SERVICE INFO

Material change for deflection pulley 532 0501 10

532 0501 10

Image 1: Previous design made of metal

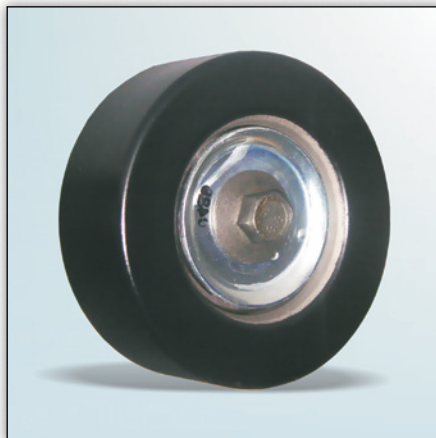
The running surface of deflector pulley 532 0501 10 has been changed from metal to plastic as part of our efforts to continuously develop our products.

It is possible that deflector pulleys with metal pulleys as well as plastic pulleys will be delivered during the transition period.

Despite the variation in design, both deflector pulleys can be used for the vehicles listed in the catalogues without restrictions.
